ANALYSIS OF MOBIL/TVA'S INTERIM MINING AND
RECLAMATION PLAN FOR PILOT TESTING OF IN SITU LEACHING
AT CROWNPOINT, MCKINLEY COUNTY, NEW MEXICO, MAY 1978

June 19, 1978

MOBIL OIL CORPORATIONS

APPENDIX B

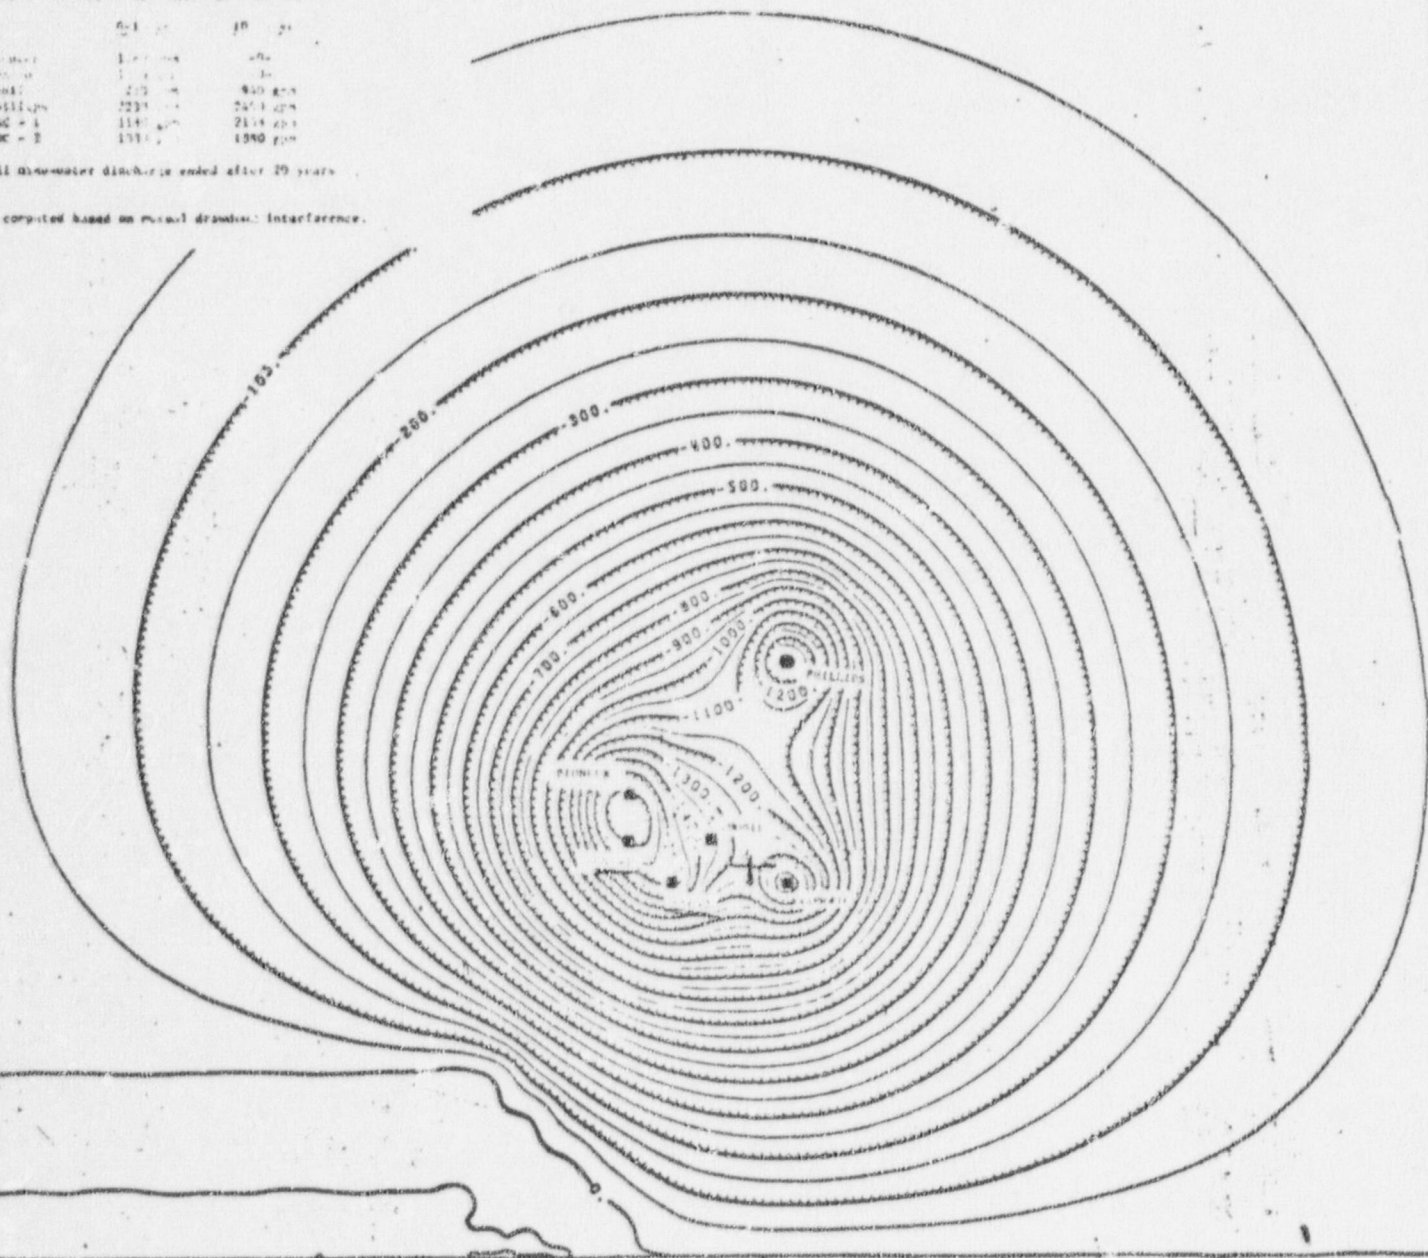
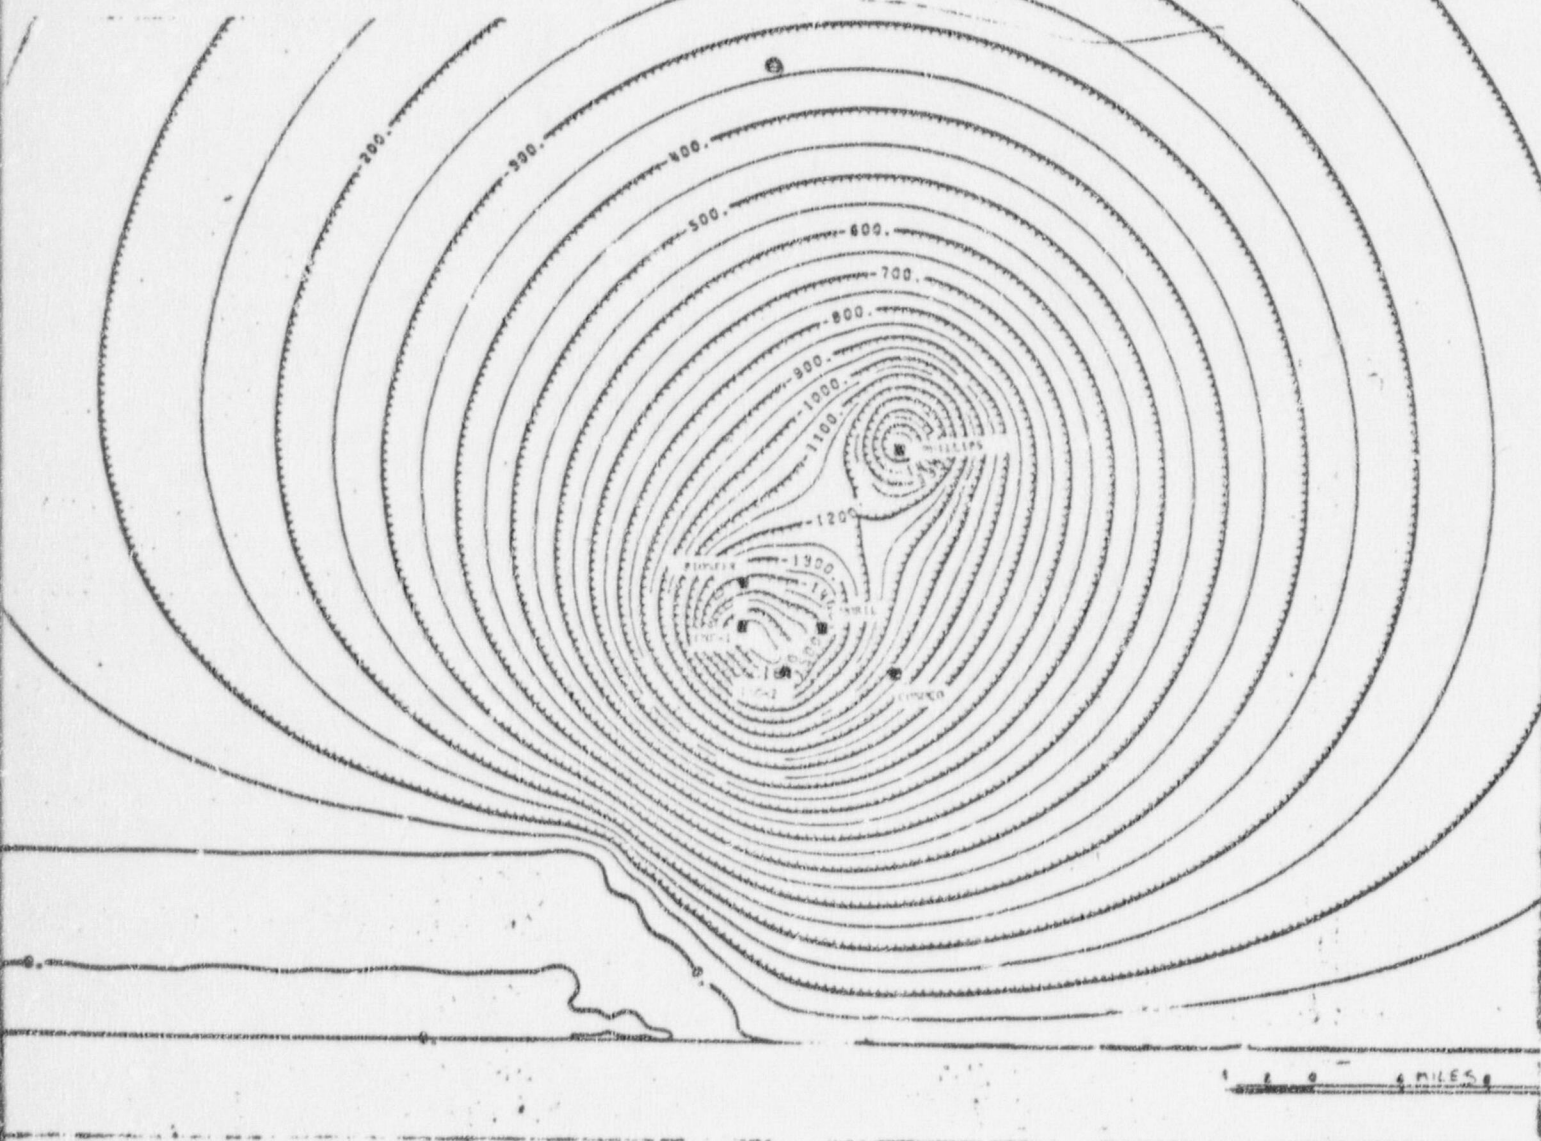
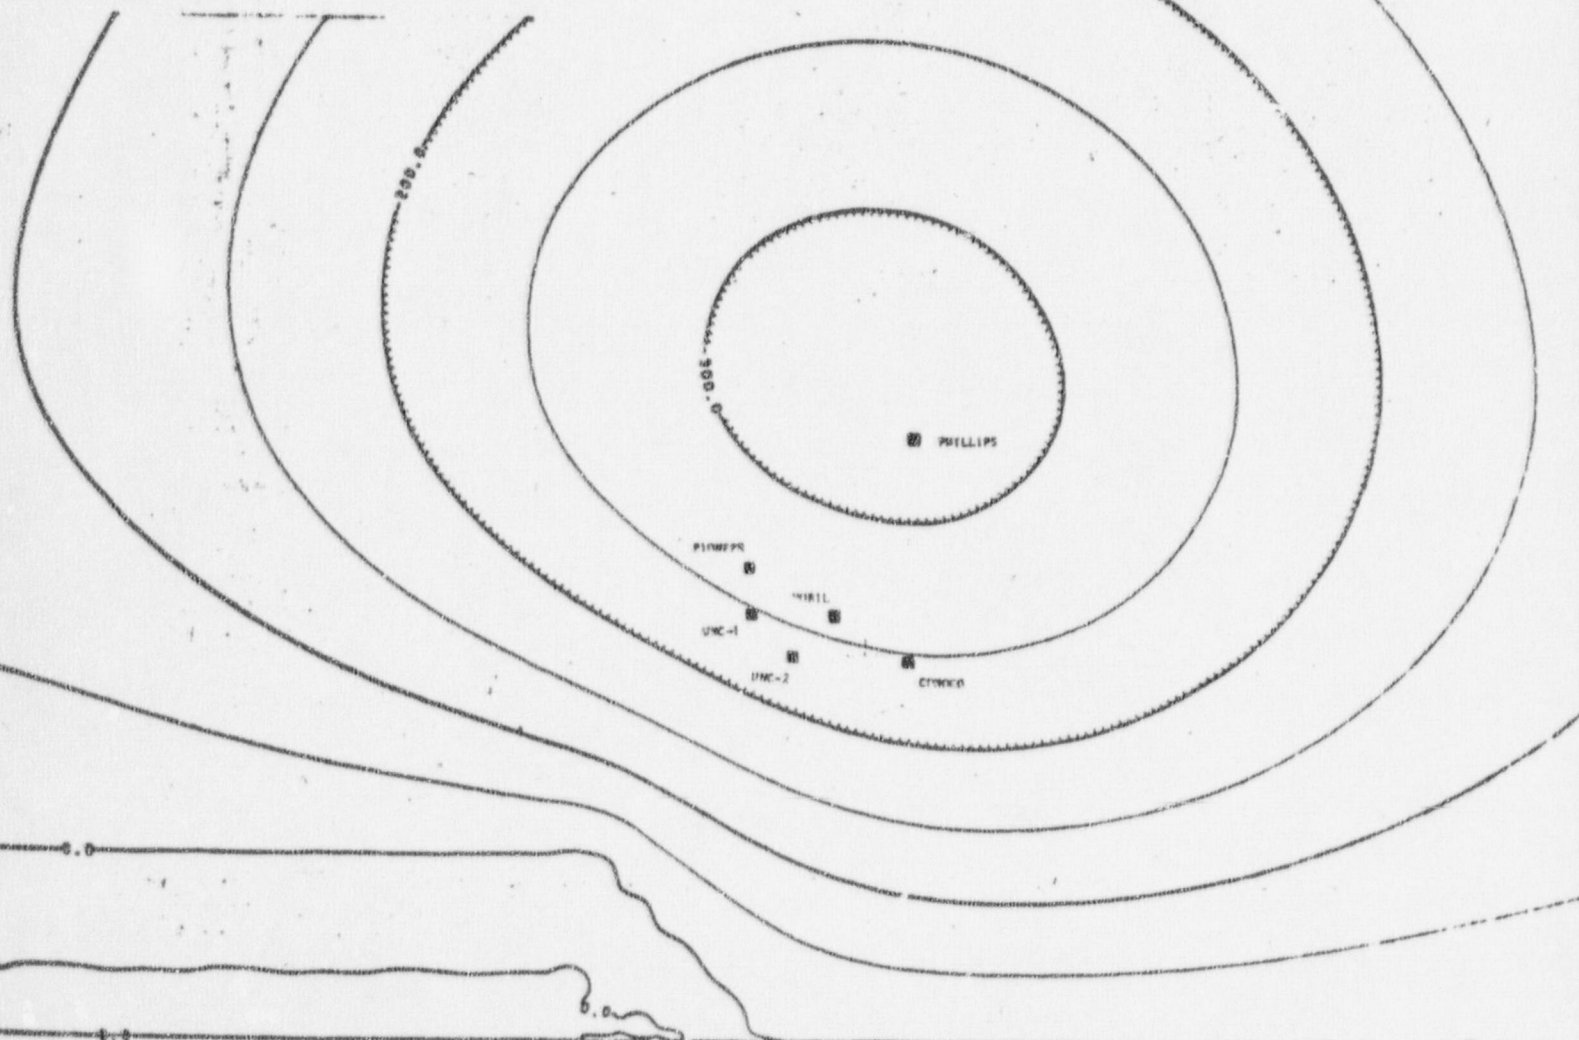
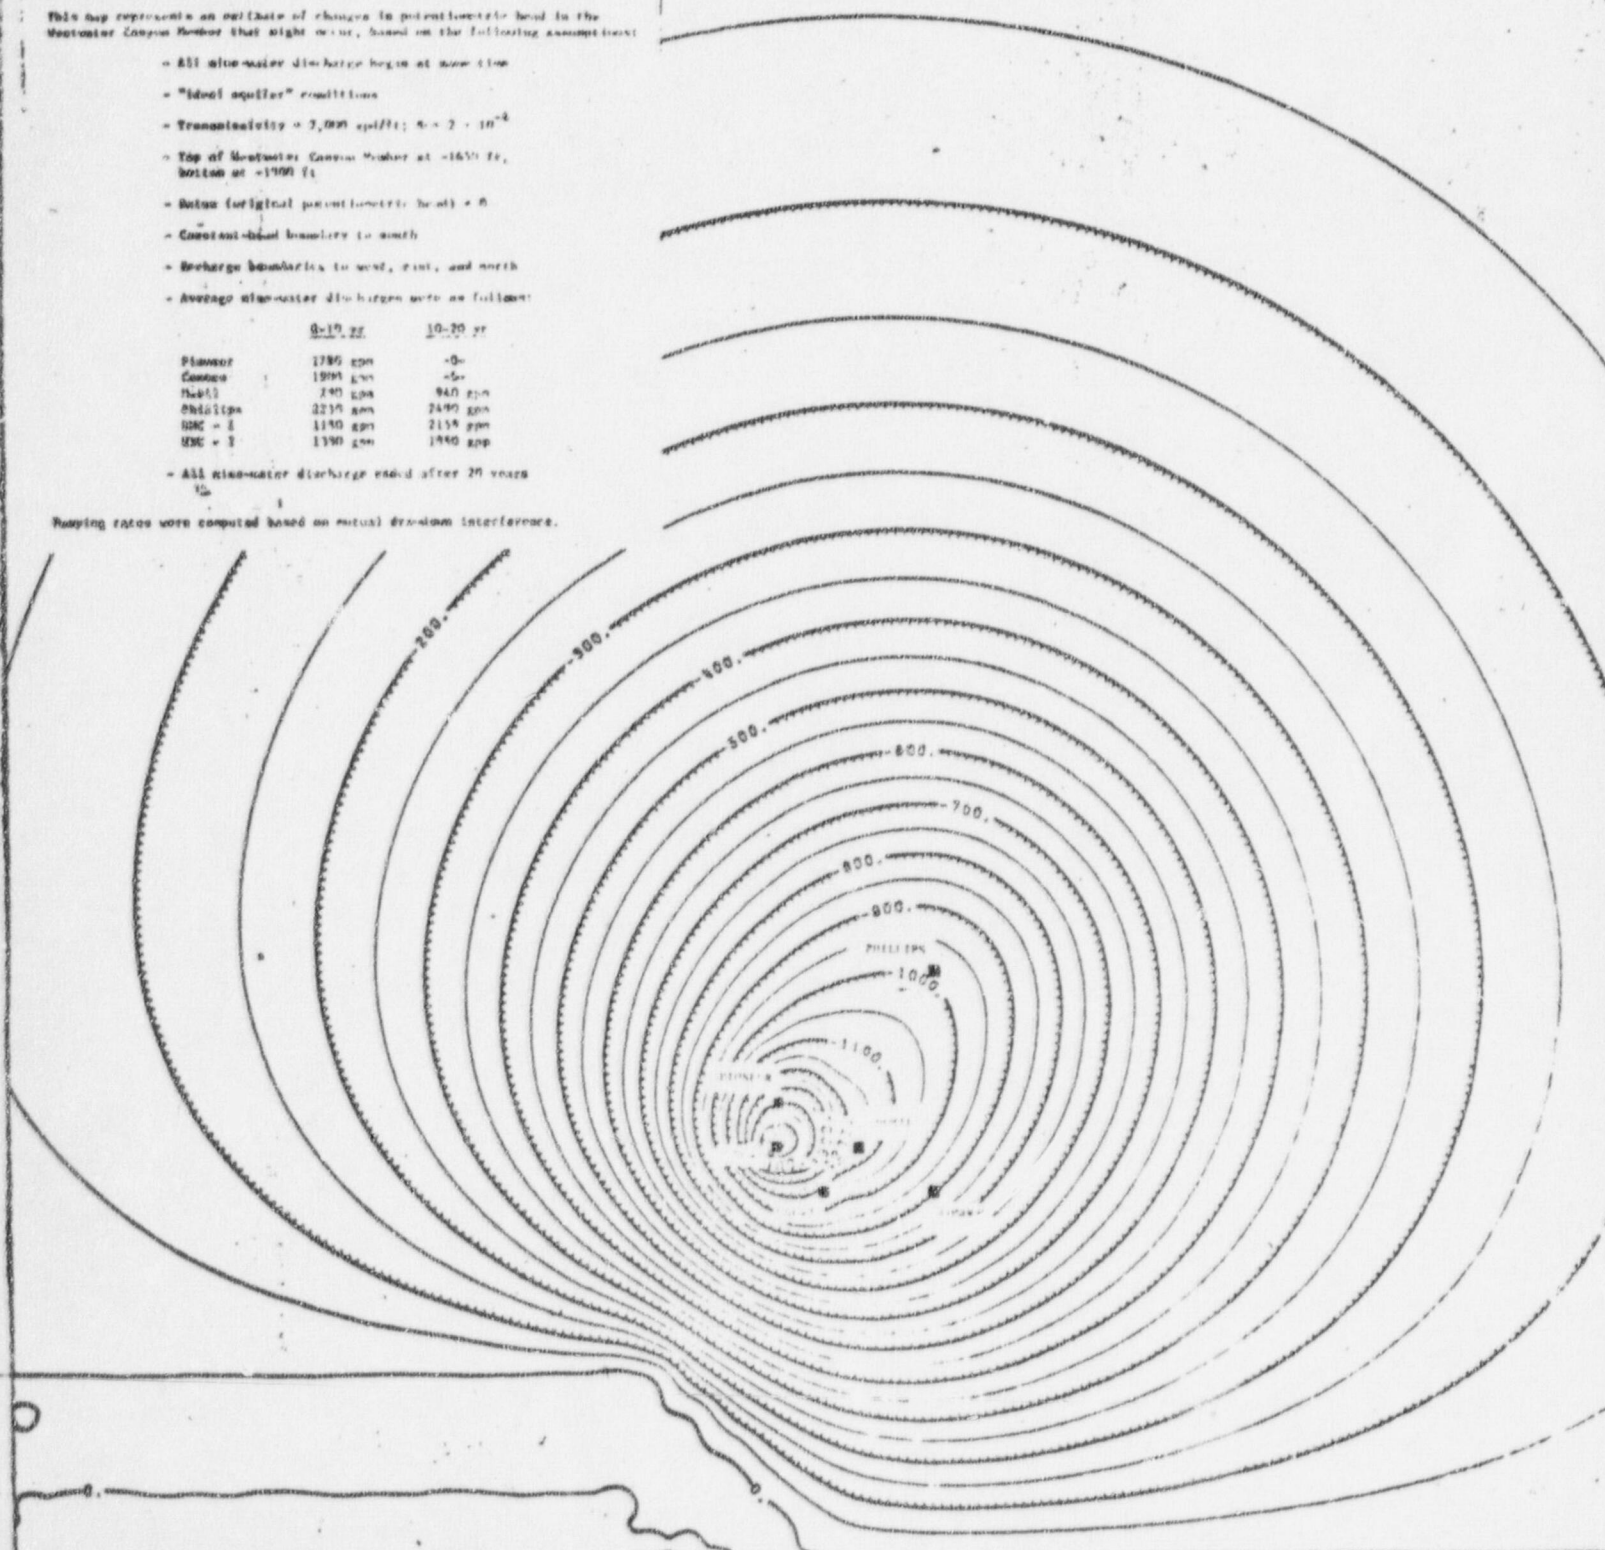
TVA has modeled the effects of the dewatering of six uranium mines (see Appendix B) -- those numbered 1, 3, 6, 7, 11, and 12 -- on page 3 of this paper. Given the seventeen mines listed on page 3, TVA's study clearly uses a low estimate of total dewatering impact. Still, this study shows major changes in the artesian head of the Westwater Canyon member. Drawdown of 1,300 feet at the in-situ site after 10 years of mine water discharge and 1,500 feet after 20 years of mine water discharge are projected. These maps from the TVA study are included as Appendix B.

The Mining Plan does not consider the impacts of these dewatering effects on the feasibility of in-situ uranium mining. The project has a 14-month production life and an 8-month restoration period. This 22-month period will be ending as the earliest projected southern San Juan Basin uranium mines begin reaching their ore zone and seriously affecting the hydrodynamics of the ore bearing zone. Thus the pilot project will occur mainly in a pristine aquifer and with full effects of dewatering being felt only as restoration -- the critical cleansing of the aquifer -- begins. The pilot project will not test "the waters" in the disequilibrium created by major mine dewatering withdrawals, which is the likely environment of any future in-situ leaching. The timing of the pilot project should be addressed by the Mining Plan.
